Waterford 3 SES
Docket No. 50-358
License No. NPF-38
Technical Specification Change Request NPF-38-232
Emergency Feedwater System

Technical Specification Change Request NPF-38-232

PROPOSED TECHNICAL SPECIFICATION

MARKUP OF CURRENT TECHNICAL SPECIFICATIONS

EFW SIMPLIFIED FLOW PATH
(FIGURE 1)

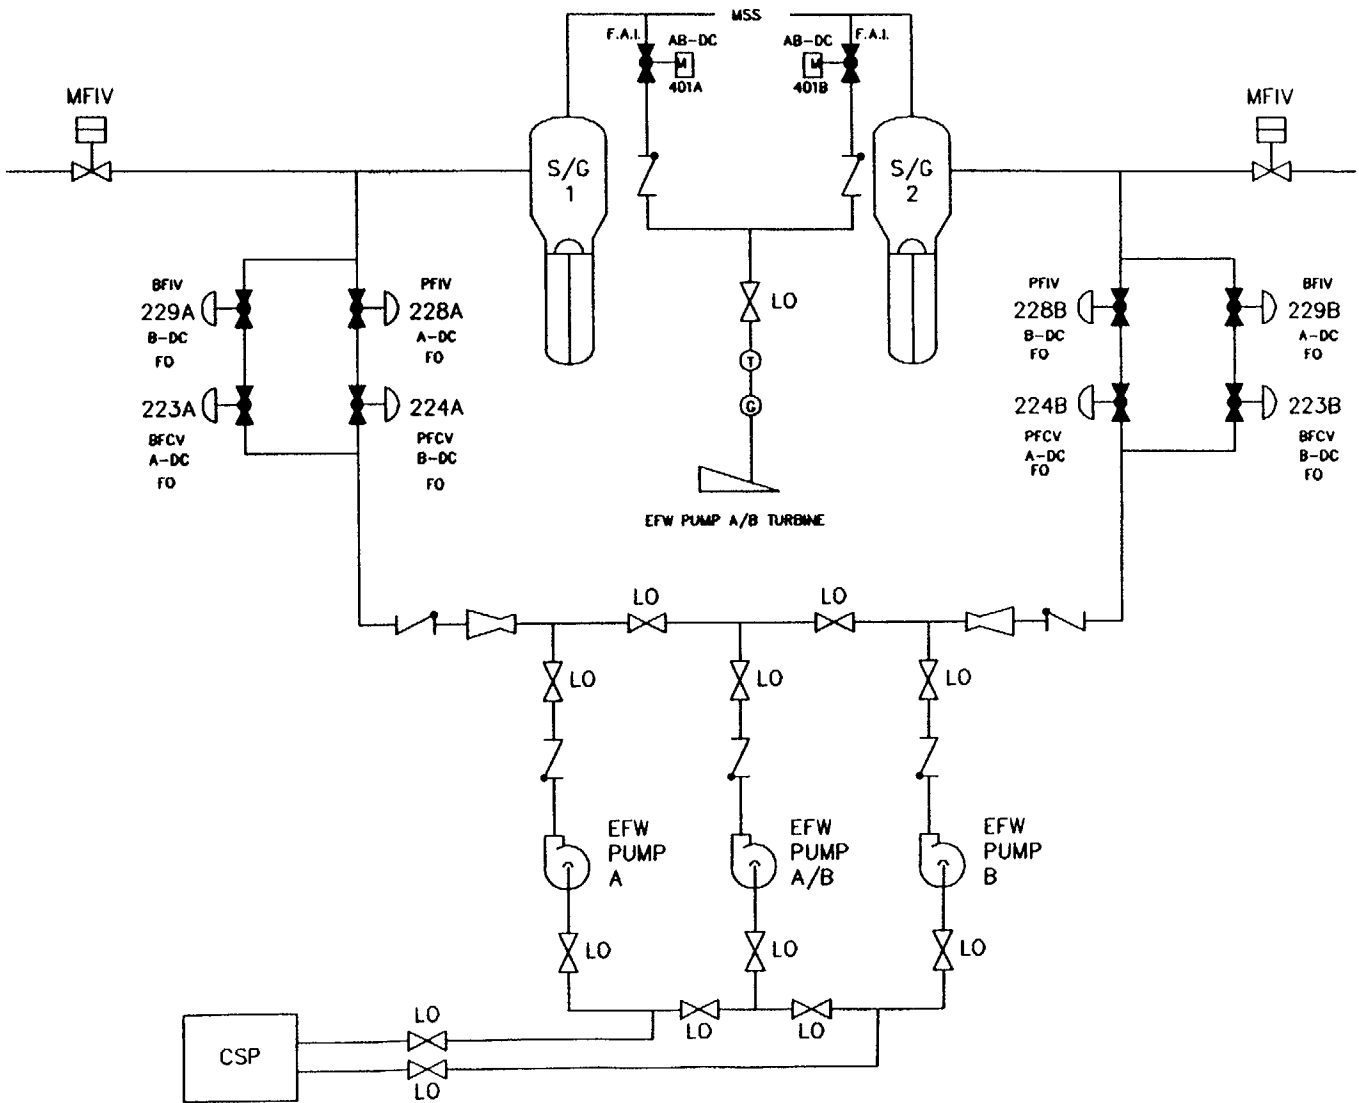
The EFW system consists of two (50% capacity) motor-driven pumps, one (100% capacity) steam turbine-driven pump, and two diverse flow paths. (Refer to page 14, Figure 1, EFW Simplified Flow Path.) One flow path supplies steam generator 1 and the second flow path supplies steam generator 2. A flow path consists of piping, valves, and components from the common pump discharge header through two parallel legs to the respective steam generator. Each parallel leg contains a flow control valve and an isolation valve in series. Either of the two parallel legs in a steam generator flow path is capable of supplying 100% of the flow required for the heat removal safety function. One flow path supplying one steam generator is capable of cooling the unit to shutdown cooling entry conditions. Two independent suction paths exist between the Condensate

As stated above, each steam generator flow path contains two parallel flow legs either of which is capable of supplying 100% of the flow required for the heat removal safety function. The flow paths contain DC powered, pneumatic, flow control and isolation valves actuated to provide flow to the appropriate steam generator by the Emergency Feedwater Actuation Signal (EFAS). Each parallel leg contains a flow control valve and an isolation valve in series. These valves are fail-open pneumatic valves. Safety-related nitrogen accumulators serve as a backup to the instrument air system for these valves. Each nitrogen accumulator supplies a pair of EFW valves (a flow control valve in one leg and the isolation valve in the redundant parallel leg of the same flow path).

Due to the diverse design of the steam generator flow paths, an inoperable flow path or paths may still be capable of delivering 100% of the required EFW flow to the respective steam generator due to the fail open design of the EFW valves and the redundant parallel legs in each flow path. The capability of one flow path to supply 100% of the required EFW flow remains available with any single flow control or isolation valve inoperable, a nitrogen accumulator inoperable, or a loss of one train of direct current (DC) power in any flow path. The design of the flow control and isolation valves in the flow path is to fail open on a loss of power or motive force (motive force is provided by instrument air and/or nitrogen). If a single valve in the flow path is inoperable (for example, mechanical binding), the valves in the associated parallel leg of the same flow path will ensure 100% flow capability remains available to supply the associated steam generator. The ability of the flow paths to perform their function with either the failure of instrument air or nitrogen to a single valve in either or both flow paths will be maintained in that redundant valves will respond to EFW logic to isolate the faulted steam generator and to supply the intact steam generator. If a flow control valve is inoperable and failed open, operator action may be required to prevent overfilling the intact steam generator.
